## **Addendum No. 4**

### **South Dade Regional Library Interior Renovations**

**C23-MDPLS-01-ESP**

**ADDENDUM NO. 4**  
16-JAN-2025

### 3.04 ADJUSTING

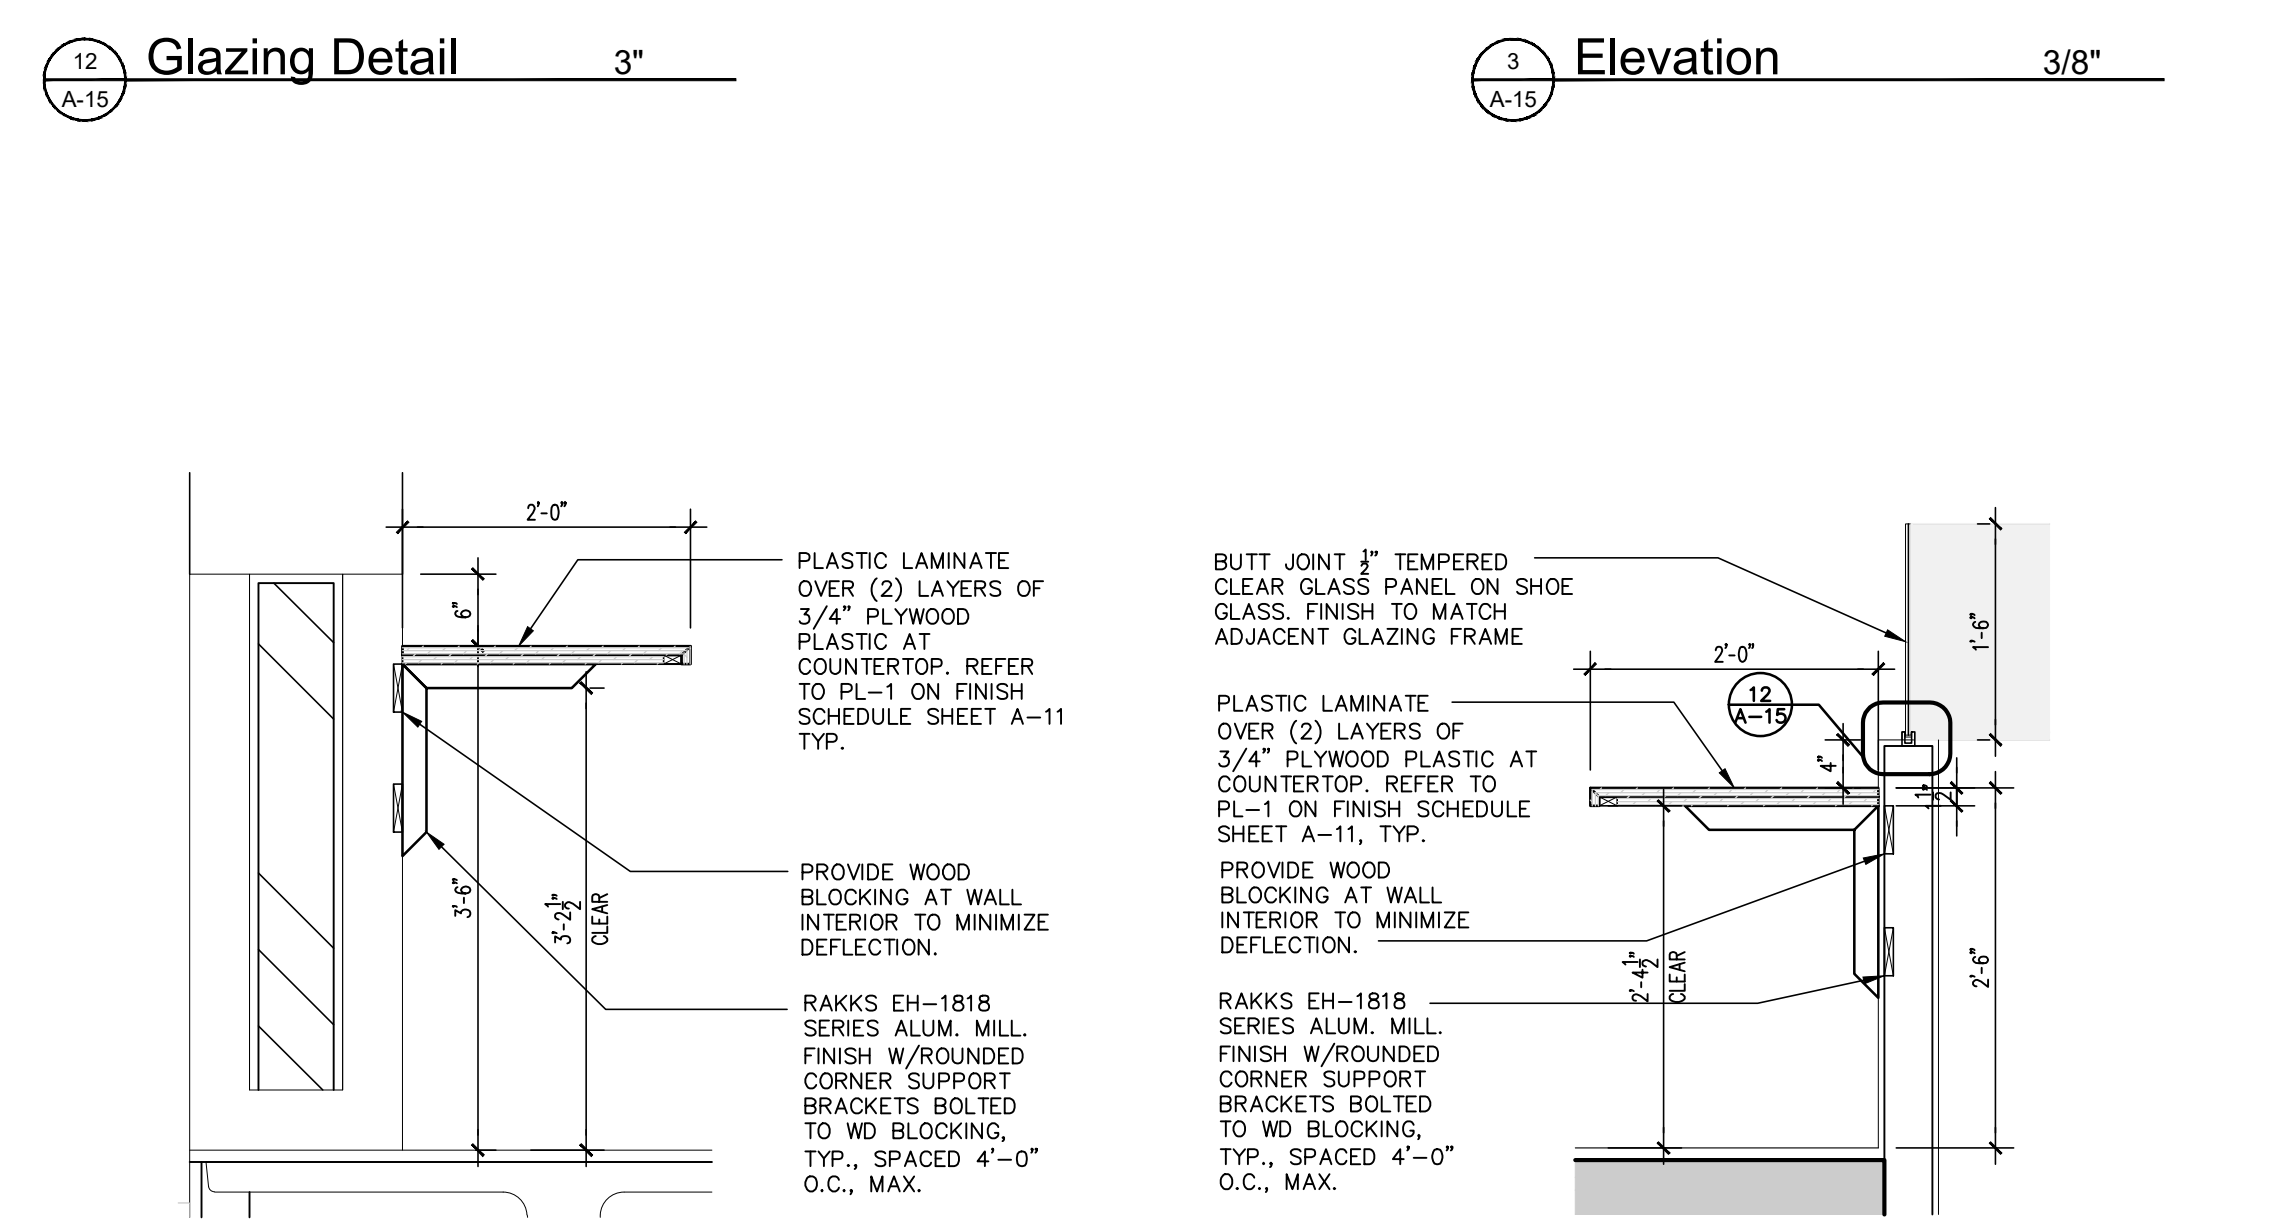
Q60. Plan Sheet A-15 shows a “Grooming Station” at the Catio space, but no manufacturer or model were found. Please clarify if grooming station is to provide and installed by Owner.

**Response Q60: “Grooming Station” refers to a 48”x30” stainless-steel worktable with sink, equal or similar to Uline Model #H-9652L. It should be provided and installed by GC.**

**GC to provide specification sheet for client/architect approval. Refer to revised sheet A-15.**
